DOCKET 50-255 - LICENSE DPR-20 - PALISADES PLANT - REPLY TO OPEN ITEM  
CONTAINED IN ROUTINE UNANNOUNCED RESIDENT INSPECTION REPORT 50-255/92016 (DRP)

REPLY TO OPEN ITEM 255/92016-01 (DRP)

Open Item 255/92016-01; Palisades Reactor Head/ Pressurizer Vent System

FIGURE 1

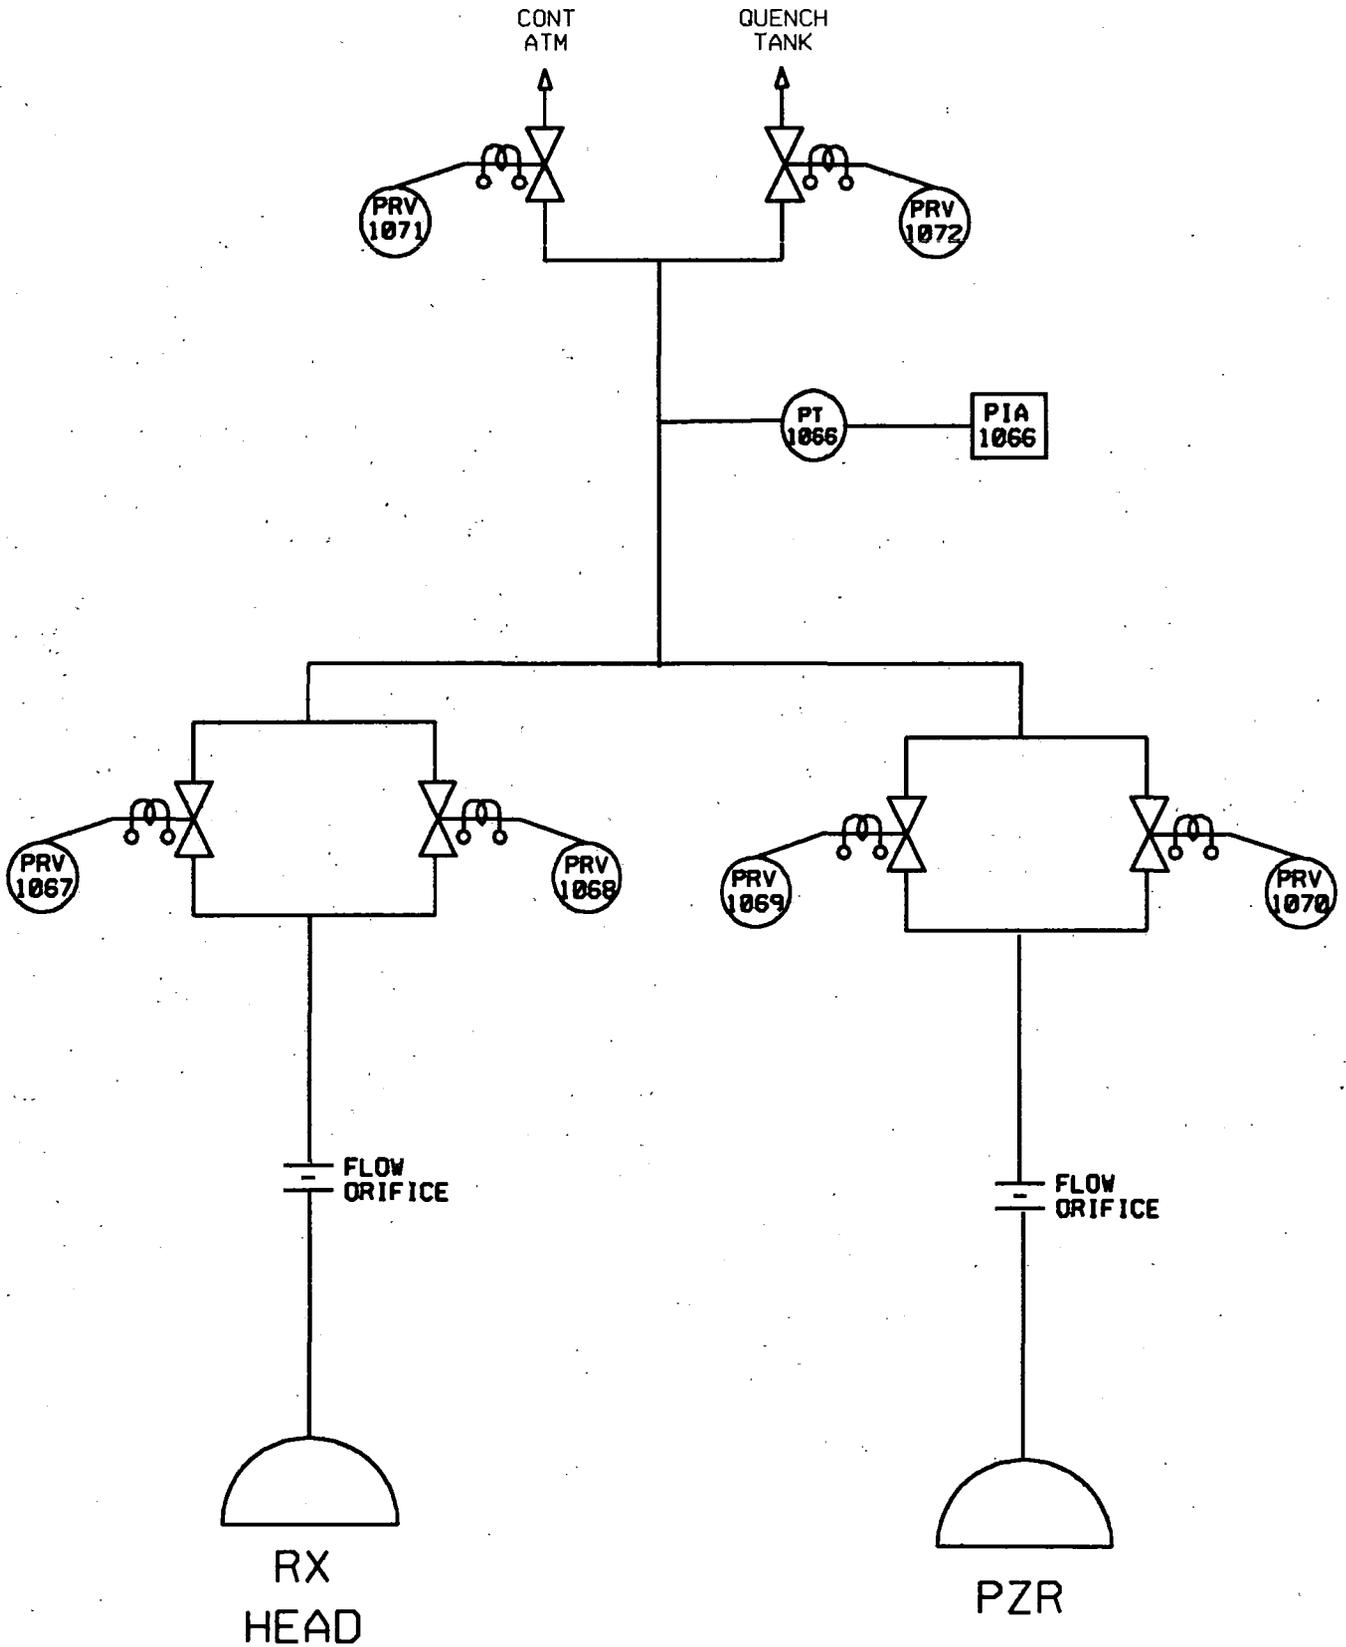
"During the post refueling outage plant heat-up, the indicated pressure on PIA-1066, "Gaseous Vent Pressure Gage," increased as the primary coolant system was pressurized. The pressure increase lagged the primary coolant system pressurization by several minutes. When steady state primary coolant conditions were achieved, the down stream isolation valves were cycled. The line de-pressurized, but was re-pressurized in several minutes.

The vent system is connected to both the reactor vessel head and pressurizer. The line relieves to either the pressurizer quench tank or directly to the containment atmosphere. The system configuration provides for dual isolation from either the head or the pressurizer to the containment atmosphere. PIA-1066 is installed on the common piping between the first and second isolation valves. The increase in pressure at PIA-1066 indicated that the second set of isolation valves were holding pressure. This was confirmed by the stable pressurizer quench tank readings and by stable containment atmospheric temperature and humidity readings.

Inspection Reports 50-255/89012(DRP), 50-255/90015(DRP) and 50-255/91009(DRP) documented that this problem has occurred in the three previous operating cycles. The work order history for this system indicated that system engineering, operations and maintenance groups have made several attempts to resolve the problem. It was unclear if the problem results from misapplication of the valves, the system configuration, maintenance problems, or some combination.

The inspector reviewed the work order history and discussed the problem with engineering, operations and maintenance personnel. The resolution of this problem is considered an open item. Since the resolution of the open item was not clear, the inspector has requested a written response to this open item (Open Item 255/92016-01(DRP))."

The isolation valves are Target Rock, one inch, pilot operated solenoid valves. The design basis of the system includes flow limiting orifices, located upstream of the reactor head and pressurizer vent isolation valves, which will limit leakage from either vent source to less than the make-up capacity of a single charging pump. The normal discharge for the vent system is to the quench tank, however redundant discharge capability is available to the containment atmosphere. It should also be noted that the piping configuration is such that opening the downstream valves will not drain the piping. The attached Figure 1 shows the vent system.

Based on the results of the testing and monitoring performed to date, we have concluded the following:

- 1) The apparent leakage of the isolation valves upstream from PIA-1066 is not a significant safety issue since the design basis relies on the flow limiting orifices.
- 2) Since the line is water solid upon start-up, containment temperature has a significant affect on the vent system pressure.
- 3) The downstream isolation valves are not leaking.
- 4) Any leakage from the upstream isolation valves due to valve degradation is very small.

Based on these conclusions, the system engineering department will continue monitoring the condition of the isolation valves and will schedule appropriate corrective action if and when the upstream valve leakage becomes significant or the downstream valves show evidence of leakage. It should be noted that testing can only be performed during heat-up and cool-down. In addition, system engineering is evaluating the design basis of the alarm function as well as methods for further testing of the upstream isolation valves to determine which of the four (4) valves are actually leaking.

Since the design basis of the vent system rests on the existence of the flow limiting orifice, the downstream isolation valves are not leaking and upstream valve leakage is minor, the small amount of leakage in the upstream valves and the resultant increase in pressure between the isolation valves is not considered to adversely affect either safe shutdown capability or the safe operation of the plant. Therefore, at this time, no additional corrective action is planned.
